Design Review Board

STAFF REPORT

(Final Review of Building and Site/Landscape Plans)

Request: Final review of building and site/landscape plan for new medical office building

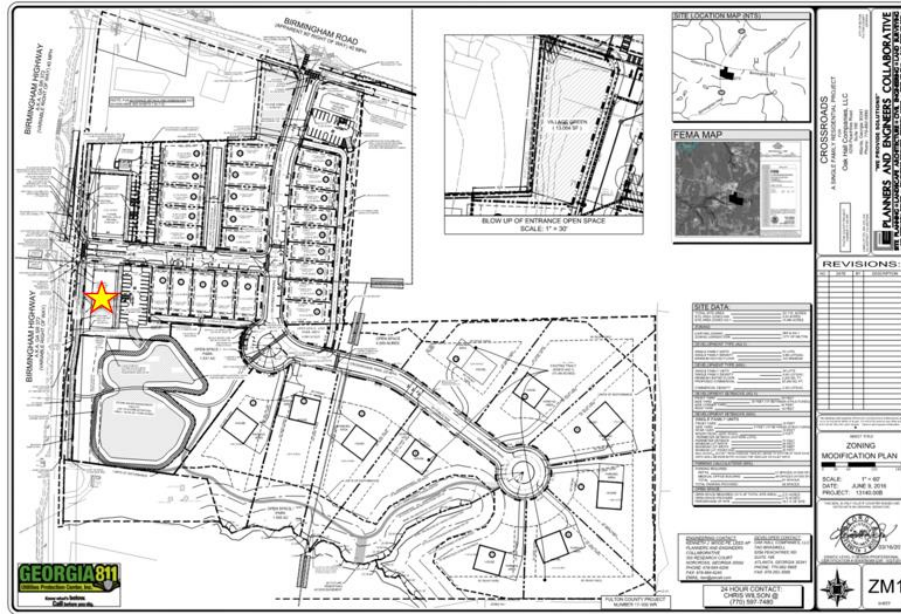
Staff received the final plan with no changes to what was originally presented to DRB. The applicant respectfully disagrees with the Board's recommendation regarding the exterior light fixture. The applicant states that the exterior wall sconces at door entrances complement the stone veneer, the color of the siding, and the overall architectural style of the building.

No further comments on the actual building design. The building plan meets the architectural standards of the Birmingham Crossroads Overlay District. Staff recommends approval with the following comments:

1. Submit a Sign Permit application for the two wall signs.
2. Any deviations to the building design/plan will have to go back to DRB for review.

Final Site and Landscape Plan submitted 3/26/25:

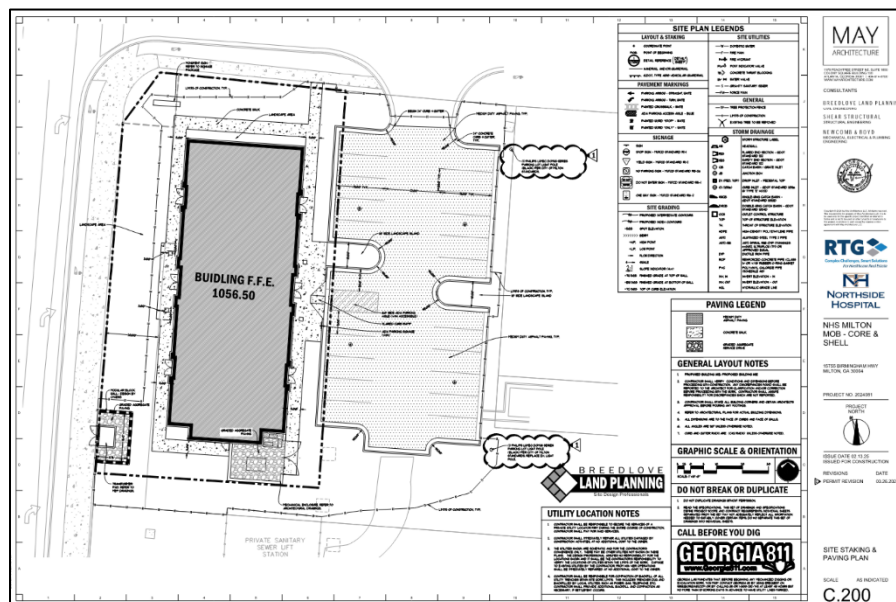
medium height trees, and 40' for large height trees.	
Trees must be trimmed up 7 feet to not impede pedestrians	The proposed trees do not impede the existing sidewalk.
Streetlights and pedestrian lights may be placed in landscape strips.	No proposed lighting in the landscape strip per the plan. All proposed lights are located in the parking lot.
Screening and Fencing	Screening is provided for the mechanical equipment located on the side of the building. No proposed fencing.
Landscape island is at least 10 feet wide and is required next to every six parking spaces in a row.	6 landscape islands are provided next to 5-6 parking spaces in a row.
Sidewalks and pedestrian paths are required along all public and private roads.	Sidewalk is already existing, and a concrete pedestrian path is provided (located around the building).
Parking lighting	5 proposed lighting (lumec domus) in the parking lot that meets the design standards for lighting.

Vehicle parking requirement for a medical office is 4 parking spaces per 1,000 SF.	The proposed total building area is 5,278 SF. Therefore, the minimum required parking is 21 spaces. There are 23 parking lights provided, which include 2 ADA spaces. This meets the minimum requirement for parking.
Accessory site features (dumpster)	No accessory site feature(s) have been identified on the site plan.

The proposed site/landscape plan meets the standards outlined in the Birmingham Crossroads Overlay District. Staff recommends approval of the site and landscape plan with the following comments:

1. Include a recent as-built survey in the revised LDP per the site engineer's comment. No LDP permit will be issued until all comments from staff have been satisfactorily met.
2. Include the photometric of the site in the LDP.
3. Any deviations to the site/landscape plan will have to go back to DRB for review.
